SERVICE LETTER 240

INSTALL TOP DECK PUMP OUT CUP DUCKBILL VALVE

Aircraft Makes/Model(s):	Float Model(s):	Compliance : Optional By : MAS	
All Aircraft		Part Number: 1011979	Approved: DRH
	All Float Models	Date: 1/30/2023	Revision: C

New 1011075 Assembly, Pumpout Plug, Duckbill

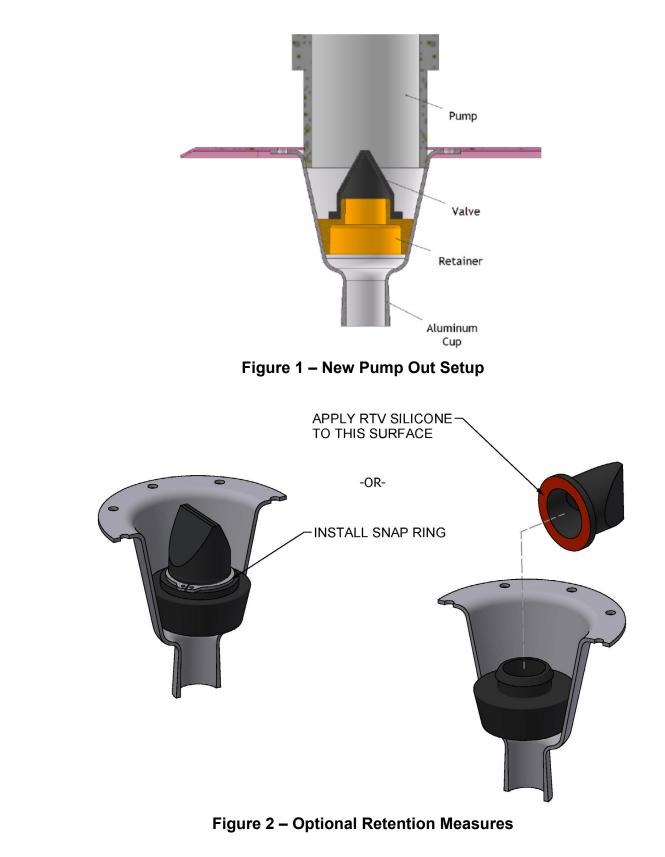
Revision	Description	
А	Initial release	
В	Removed and obsoleted Kit 1011979-01. Updated items list and added 1011075.	
С	Added duckbill valve retention measures. Updated effectivity, background, compliance method. Added optional parts list. Updated work instructions and added Figure 2.

Pump out plugs p/n 2111 do not always stay lodged in the cup. A new design includes a retainer that is installed in the cup with clear RTV adhesive (or equivalent) and a rubber, replaceable "Duckbill" valve. This will also allow pumping out water from the float without pulling the plug. See Figure 1 at the end of this service letter. This letter also describes optional methods for increasing retention of the rubber duckbill component, which can be especially useful when exposed to contaminating fluids or prying wildlife.

- a. Remove the current plug
- b. Clean the cup from dirt and debris. Use IPA or proper cleaner as prep for adhesive.
- c. Using clear RTV or equivalent (any color can be used), install the retainer in the cup.
- d. After adhesive has cured, install the duckbill valve onto the retainer.
- 2. (OPTIONAL) Additional measures for retention of duckbill valve (see Figure 2):
 - a. Using snap ring pliers, install snap ring (see table for p/n) so that it is seated against the upper surface of the duckbill valve flange but below the barb of the retainer, or:
 - b. Clean the mating surfaces and apply RTV below/around the duckbill valve flange where it meets the retainer. Beginning with a few light dabs is recommended, increasing as required.
